Grid Code Modification Proposal Form

GC0155: Clarification of Fault Ride Through Technical Requirements

Overview: An alternative to GC0151 which addressed the Fault Ride Through (FRT) compliance process and proposed minor improvements to the FRT technical requirements. This alternative was insufficiently scrutinised as part of the GC0151 urgent modification process hence Ofgem, while rejecting it in their decision letter dated 8 November 2021, noted that it had merit and should be brought forward subsequently.

Figure 1 showing theoretical worst case fault which plant must be capable of riding through

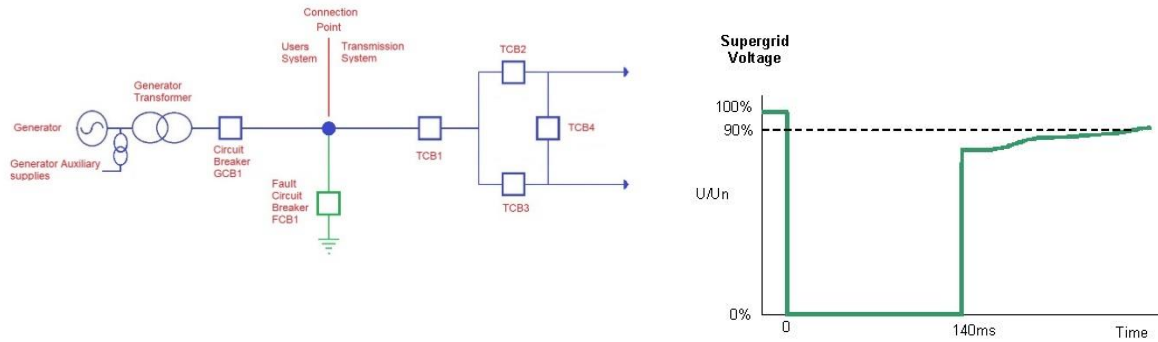
The new section CC.6.3.15(a)(i)(a) will only deal with plant capabilities by clarifying that the plant has to be capable of riding through the worst fault that the network could impose which is a 3-phase short circuit at the connection point which lasts for up to 140ms as shown in figure 1 below. To achieve this, the words “be design to” will be added to section CC.6.3.15(a)(i)(a) as can be seen in the legal text in appendix 1.

Figure 2 showing a fault which can be cleared by transmission system breakers TCB3 & 4

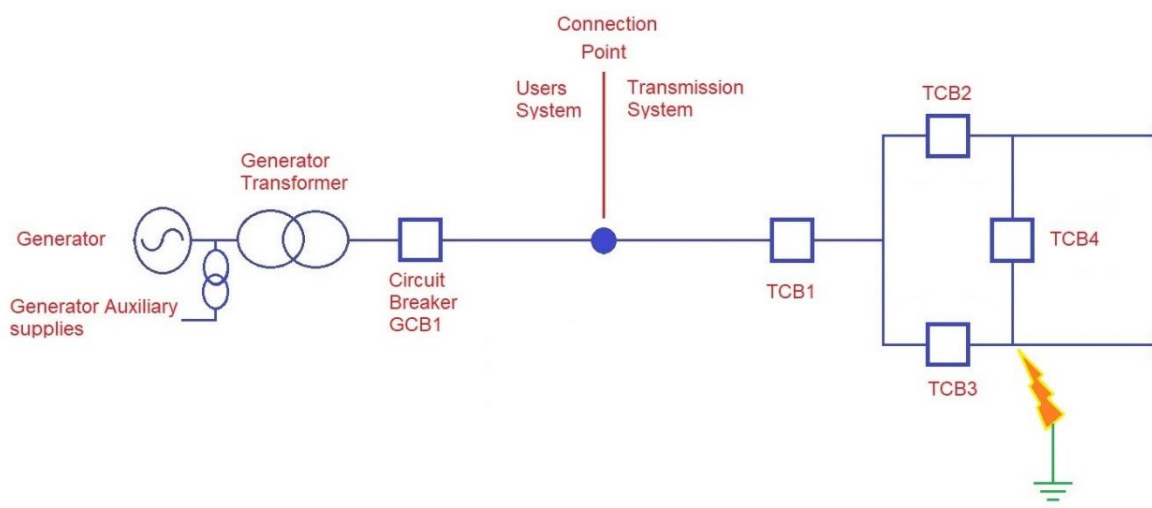
The new section CC.6.3.15(a)(i)(b) will specify the actions to be taken if a fault occurs by requiring that plants ride through faults in the transmission system which can be cleared by the transmission system circuit breaker as shown in figure 2 below and by adding the following text as the introduction to the section

Whilst the introduction to this section deals with plants riding through faults as it is currently drafted in the Grid Code, it is not clear what is supposed to happen where the plant's circuit breaker has to open to clear the fault. There are concerns that the current text could be interpreted that the plant shall remain connected feeding the fault for 140ms which could lead to dangerous situations. It is clear this is not the intent, and that plant should trip during these circumstances. It is proposed that the following subclauses are added to clarify each situation where tripping is permitted.

- (b) Each **Generating Unit, DC Converter, or Power Park Module** and any constituent **Power Park Unit** thereof and **OTSDUW Plant and Apparatus** shall remain transiently stable and connected to the **System** without tripping of any **Generating Unit, DC Converter or Power Park Module** and / or any constituent **Power Park Unit, OTSDUW Plant and Apparatus**, and for **Plant and Apparatus** installed on or after 1 December 2017, reactive compensation equipment, for any balanced and unbalanced fault where subjected to a voltage dip at either the **Onshore Grid Entry Point or Interface Point** as applicable where the voltage remains either on or within the envelope shown in figure CC.6.3.15(a)(i)(a) except where:

Figure 3 showing a fault which can only be cleared by generator breakers GCB1

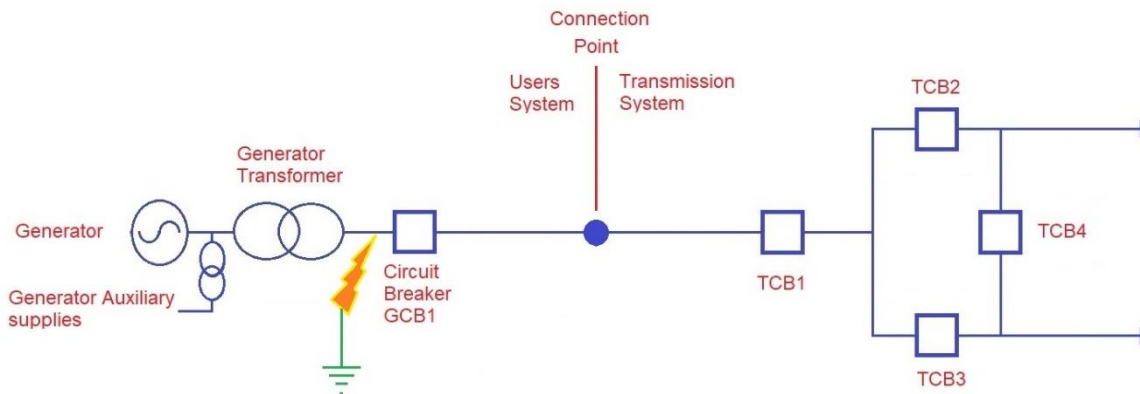
Firstly if the fault is on the Generator's equipment then the Generator shall be required to trip to clear the fault from the transmission system as detailed in the proposed new section CC.6.3.15(a)(ii)(b)(i) (note that this is already permitted in the ECCs), as follows:-

Power Park Module and any constituent **Power Park Unit** thereof and **OTSDUW Plant and Apparatus** shall trip to clear the fault from the **Transmission System**. The protection schemes and settings should not jeopardise **Fault Ride Through** performance as specified in CC.6.3.15.1

Figure 4 showing a fault which can only be cleared by generator breaker GCB1 & transmission circuit breaker TCB1

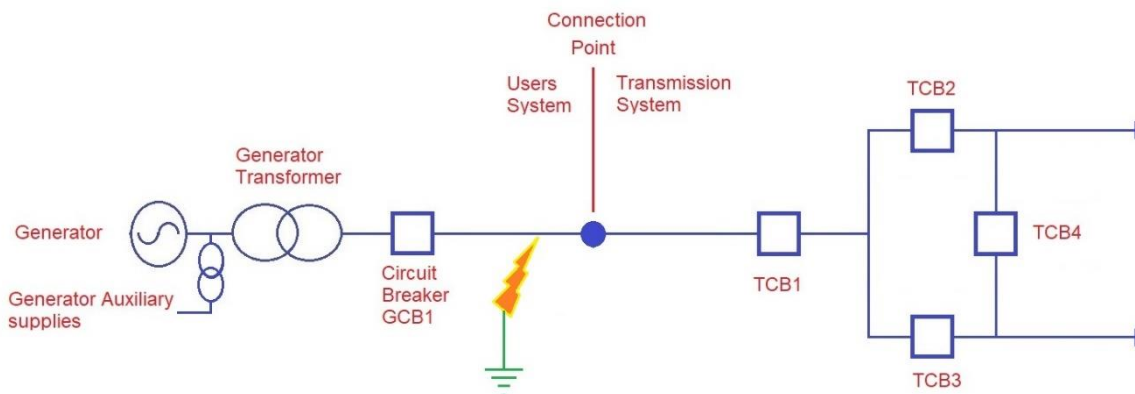
Secondly if the location of the fault on the network that means that the fault can only be cleared by operation of both Transmission and the Generator circuit breaker as shown in figure 4, again the Generator will be permitted to trip to clear the fault as detailed in the proposed new section CC.6.3.15(a)(i)(b)(ii) and ECC.6.3.15.8(vi)(i), as follows:-

the location of the fault means it cannot be fully cleared without tripping the of **Generating Unit, DC Converter, or Power Park Module** and any constituent **Power Park Unit** thereof and the **OTSDUW Plant** shall trip as required.

Figure 5 showing a fault which can be cleared by transmission breakers TCB1,2&3, however this results in the Generator being islanded from the main transmission system and needs to come off

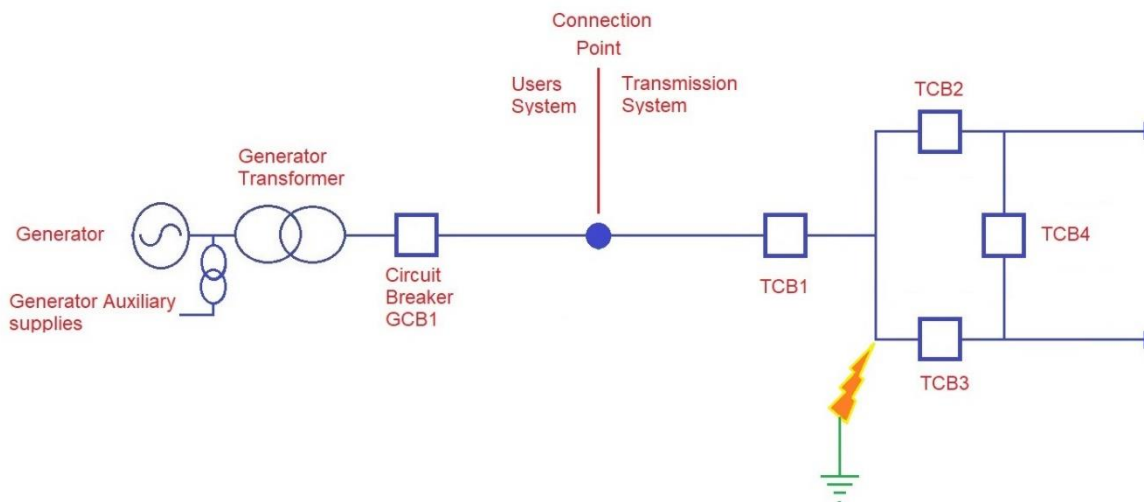
Thirdly, if the location of the fault on the network means that the Generator will become islanded by the operation of the transmission circuit breakers as shown in figure 5 then it shall be permitted to trip as detailed in the proposed new sections CC.6.3.15(a)(ii)(b)(iii) and ECC.6.3.15.8(vi)(ii), as follows:-

clearance of the fault results in the **Generating Unit, DC Converter, or Power Park Module or OTSDUW Plant** becoming islanded and disconnected from the **Total System** and not supplying **Customers** (where CC.6.3.7(c)(i) applies), then the **Generating Unit, DC Converter, or OTSDUW Plants** shall be permitted to trip as required.

Figure 7 showing the proposed reactive current injection requirements, requiring the current to always remain above the black line

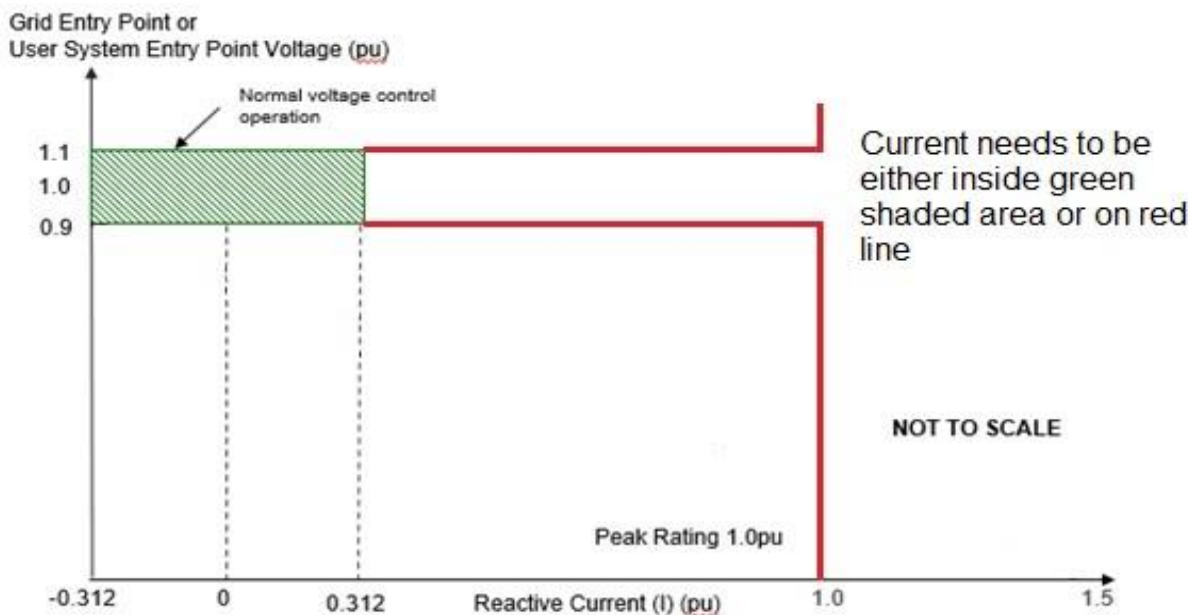
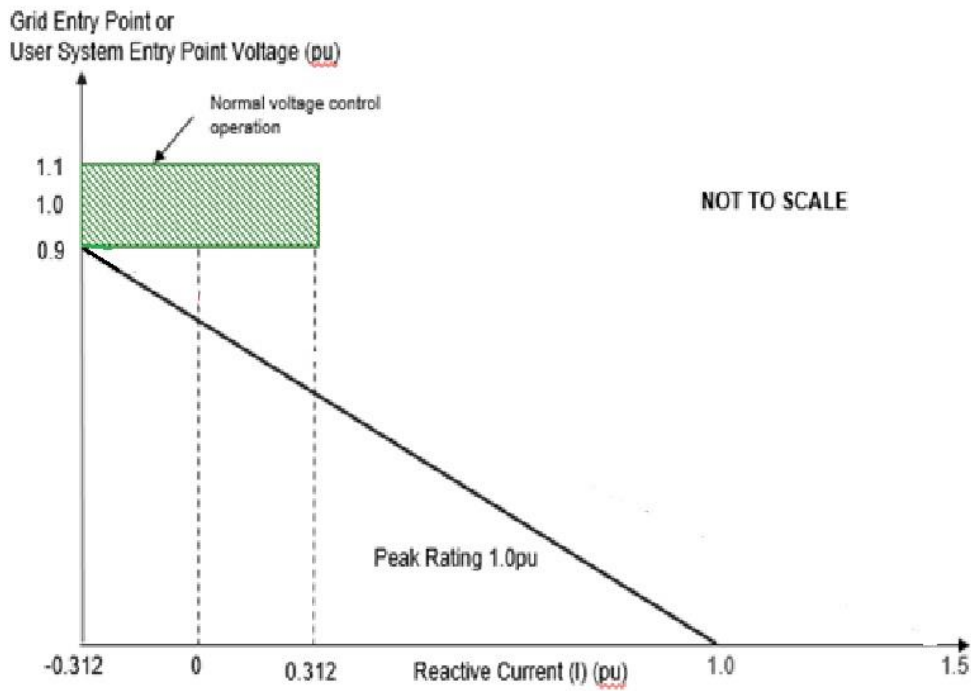
The area of the current legal text which technically creates the biggest problem in relation to compliance are in sections CC.6.3.15 (a)(ii) and ECC.6.3.15.9.2.1(a)(i) which currently state "for which the voltage at the Grid Entry Point (or Interface Point in the case of OTSDUW Plant and Apparatus) is outside the limits specified in CC.6.1.4, each Generating Unit or Power Park Module or OTSDUW Plant and Apparatus shall generate maximum reactive current". If this requirement is drawn out on the figure 6 below where the current and voltage must always either be within the green shaded area or on the red line.

The reason this creates compliance issues is: as drafted, very few plants (if any) actually do this and it has presumably drifted in as a drafting oversight relating to PPM requirements. This issue has previously been identified in the workgroup GC0111 on Fast Fault Current injection and in the GC0137 VSM workgroup and has been fixed for new PPMs, however currently all synchronous Generator and older PPM will technically be non-compliant with this FRT requirement as drafted. This issue was dealt with in GC0111 by adding a new Figure ECC.6.3.16(a), however this is more onerous than is required for GB Users so the graph shown in figure 7 is proposed with text changes as follows:-

- (iv) During the period of the fault as detailed in CC.6.3.15.1 (a) (i) for which the voltage at the **Grid Entry Point** (or **Interface Point** in the case of **OTSDUW Plant and Apparatus**) is outside the limits specified in CC.6.1.4, each **Generating Unit** or **Power Park Module** or **OTSDUW Plant and Apparatus** shall inject a reactive current above the heavy black line shown in Figure CC.6.3.15(b) without exceeding the transient rating limit of the **Generating Unit, OTSDUW Plant and Apparatus** or **Power Park Module** and / or any constituent **Power Park Unit** or reactive compensation equipment.

Figure 8 showing a typical active power response of a unit at low load to a fault

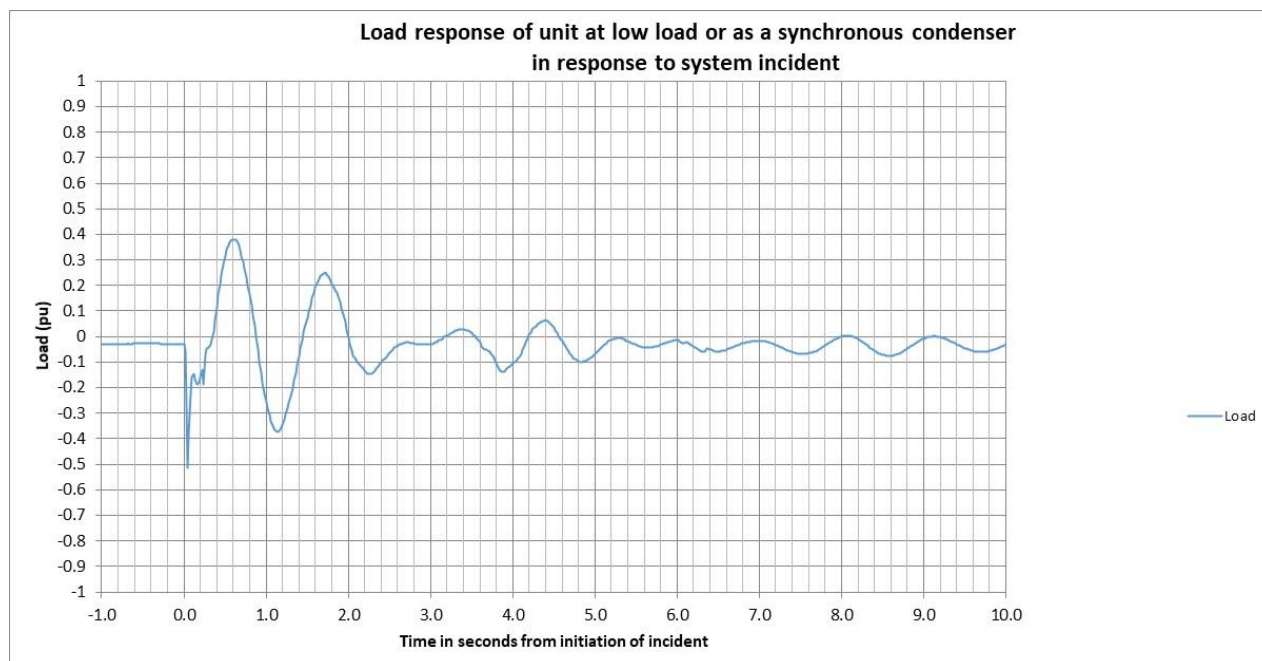
Whilst this works in principle at higher loads, it does create an issue at lower loads if you consider a real event for a unit operating as a synchronous condenser in figure 8.

If you look at the initial load which is 0.02 pu then 90% of this small number you get a very small number, it is also difficult to see how a sensible compliance assessment can be carried out at these levels and it is hence suggested that under these circumstances the tolerance should be changed.
